# HISTORIC AND DESIGN REVIEW COMMISSION

May 04, 2022

**HDRC CASE NO:** 2022-229  
**ADDRESS:** 315 LEIGH ST  
**LEGAL DESCRIPTION:** NCB 721 BLK 3 LOT S 100.7 FT OF 4  
**ZONING:** RM-4, H  
**CITY COUNCIL DIST.:** 1  
**DISTRICT:** Lavaca Historic District  
**APPLICANT:** Nate Manfred/French & Michigan  
**OWNER:** Tina Dellinger/DELLINGER TINA FARRIS  
**TYPE OF WORK:** Construction of a rear addition, carport and screened porch  
**APPLICATION RECEIVED:** April 15, 2022  
**60-DAY REVIEW:** Not applicable due to City Council Emergency Orders  
**CASE MANAGER:** Edward Hall  
**REQUEST:**

The applicant is requesting a Certificate of Appropriateness for approval to:

## **Location of the New Addition and Carport**

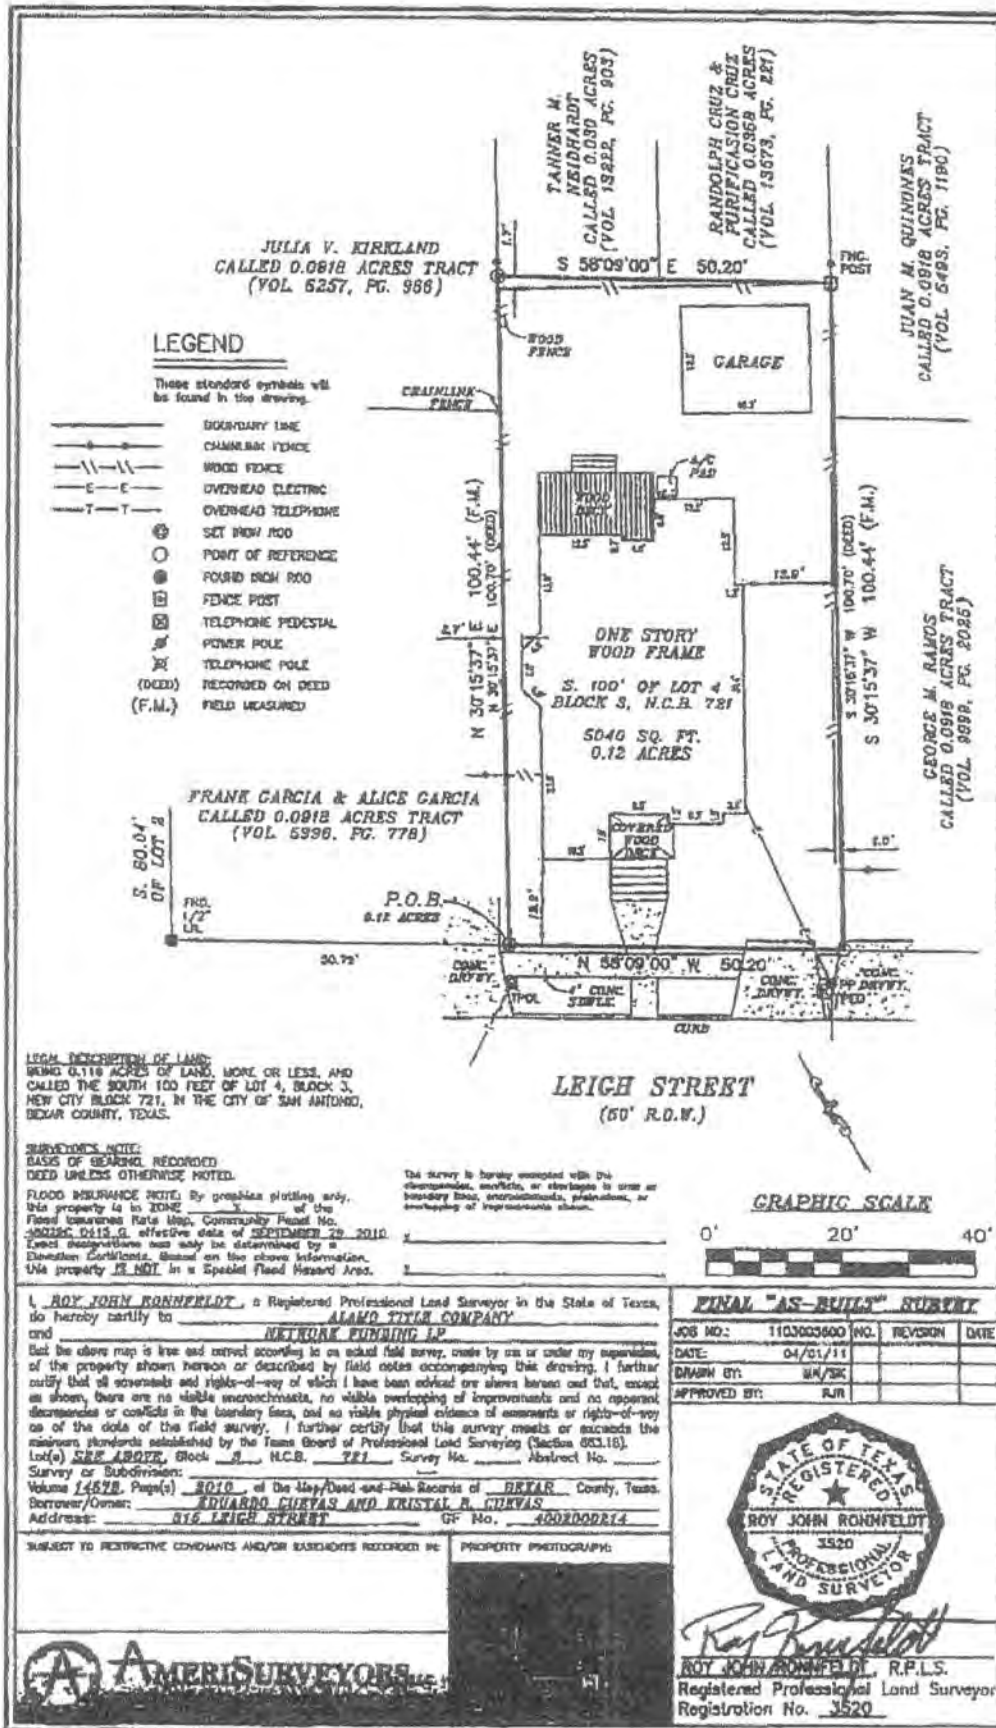
The garage is currently 3'-3" from the side property line and 3'-10" from the back property line. We are proposing that the new addition located 3'-7" from the side property line and 5'-0" from the back property line, making the new structure further from the property lines than the current garage.

## Floor Plan

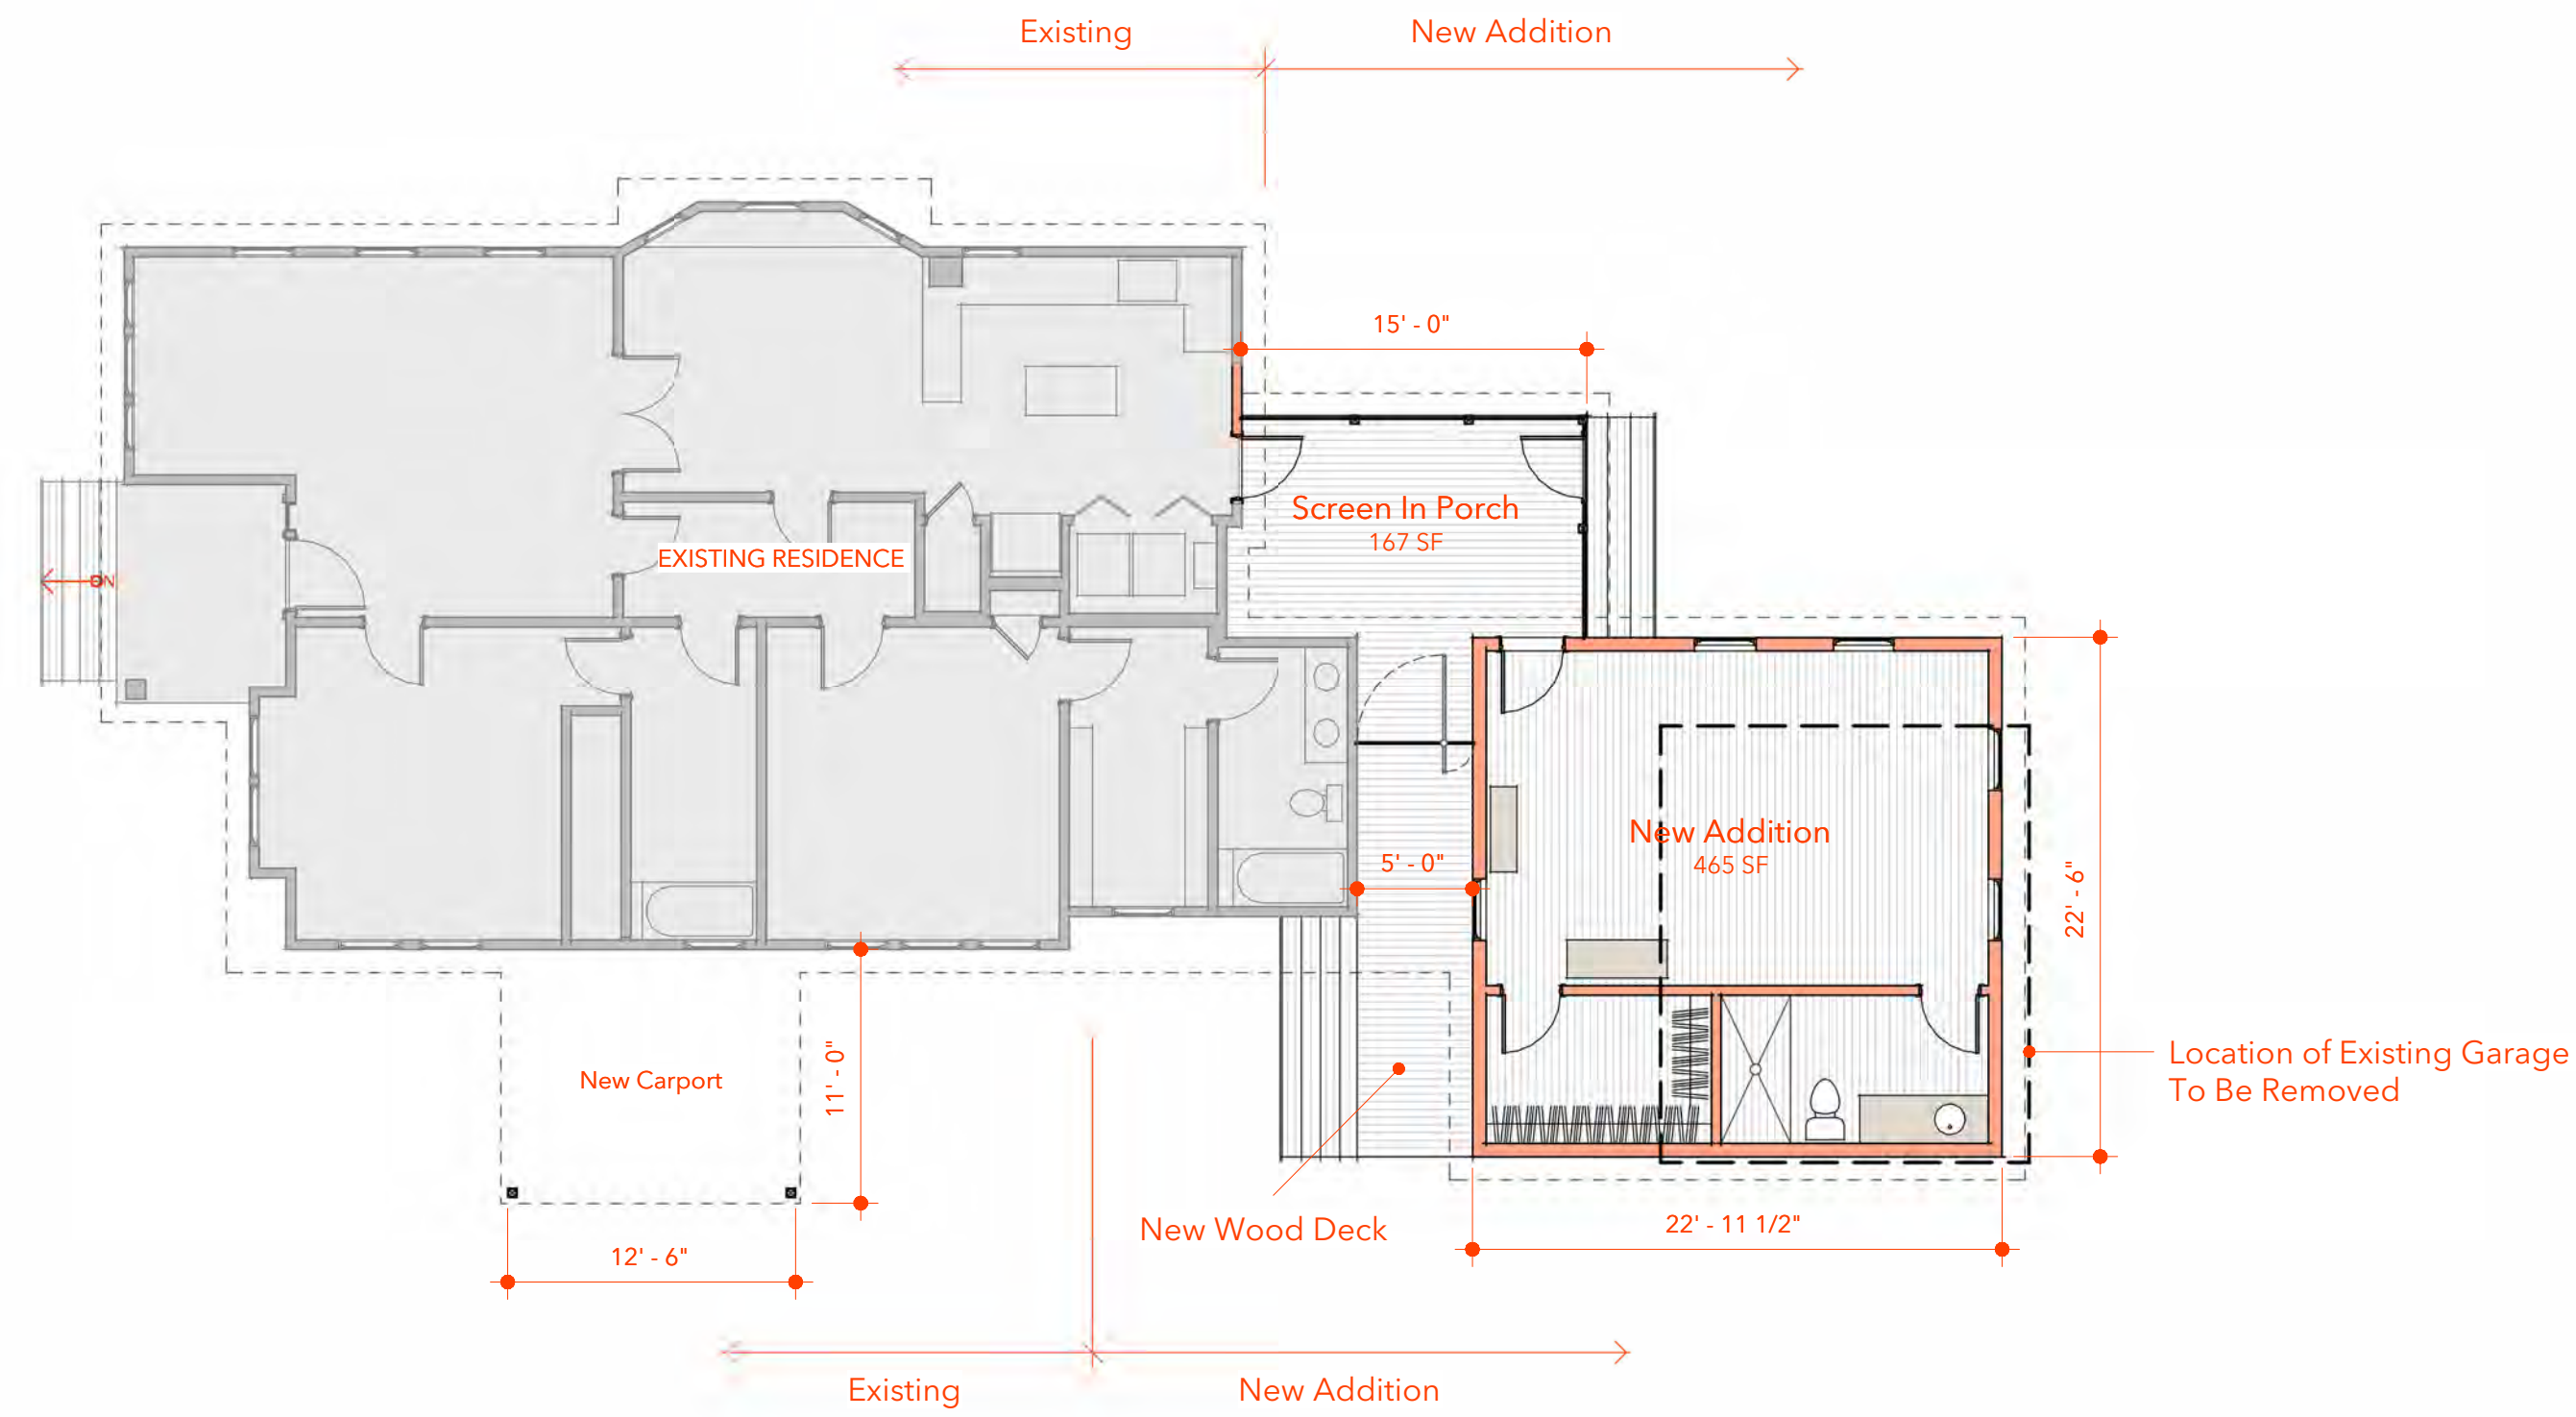
- c. **REAR ADDITION** – The applicant has proposed to construct a rear addition to feature 456 square feet.
- d. **REAR ADDITION** – The Guidelines for Additions 1.A. notes that additions should be sited to minimize view from the public right of way, should be designed to be in keeping with the existing, historic context of the block, should feature similar roof forms, and should feature a transition to differentiate the new addition from the historic structure. Additionally, the Guidelines for Additions 1.B notes that additions should be subordinate to the principal façade of the historic structure, should feature a footprint that responds to the size of the lot, should not double the existing building footprint, and should feature an overall height that is generally consistent with that of the historic structure. Generally, staff finds the proposed addition to be appropriate. While the addition will extend to the side of the original footprint, staff finds that its location towards the rear of the lot is subordinate in view and massing.

- i. **SCREENED PORCH** – The applicant has proposed to construct a screened porch that will connect the proposed, conditioned addition to the historic structure. The porch will feature a wood deck, a wood framed screening element, and a flat roof. Generally, staff finds the proposed screened porch to be appropriate.

- j. **CARPORT** – On the east side of the historic structure the applicant has proposed to construct a carport. The proposed carport will be attached to the historic structure. Generally, staff finds the installation of a carport on the east side of the historic structure to be appropriate; however, staff finds that the carport structure should be detached from the historic structure. Staff also finds that a location further to the rear of the historic structure would be most appropriate.

1. Staff recommends approval of item #1, the construction of a rear addition based on findings c through h with the following stipulations:
  - i. That the proposed clad windows be consistent with staff's standards for windows in additions and new construction.
  - ii. That the proposed rectangular, fixed windows be replaced by windows that feature traditional sizes in a sash configuration.
2. Staff recommends approval of item #2, the construction of a screened porch, as submitted, based on finding i.
3. Staff recommends approval of item #3, the construction of a side carport with the following stipulation:
  - i. That the proposed carport be detached from the primary historic structure.

## Site Plan + Roof Plan

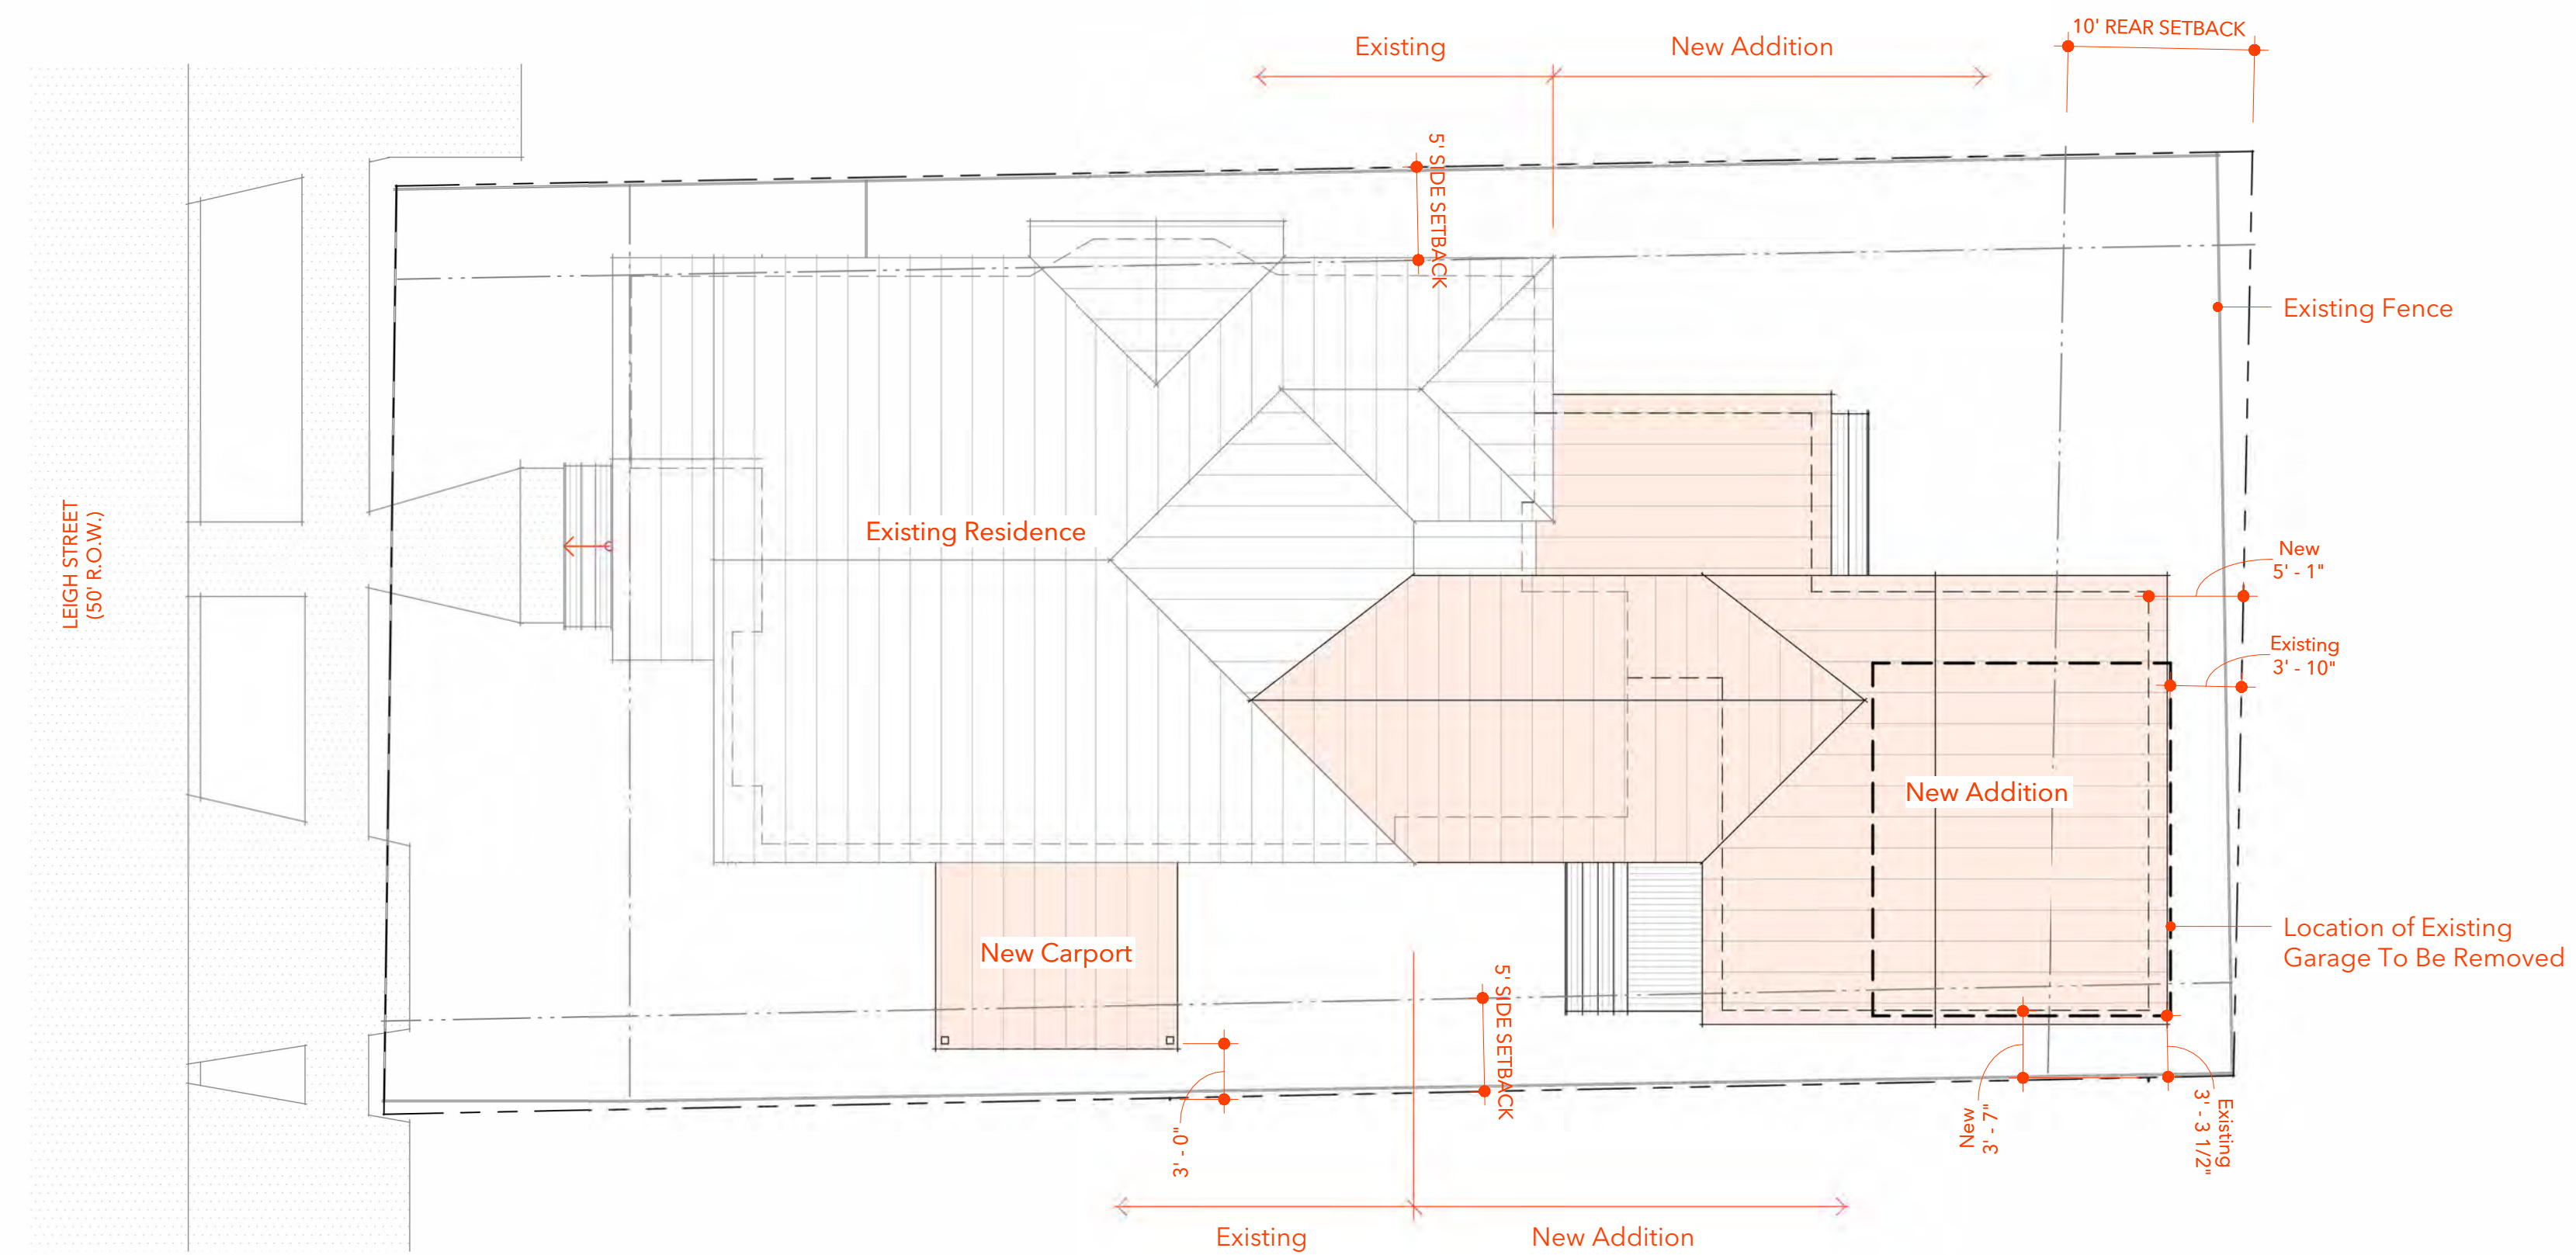
- g. **ROOF FORM** – The applicant has proposed for the rear addition to feature a side facing gabled roof. Overall, the proposed roof form will be subordinate to that of the historic structures. Staff finds the proposed roof form to be appropriate.
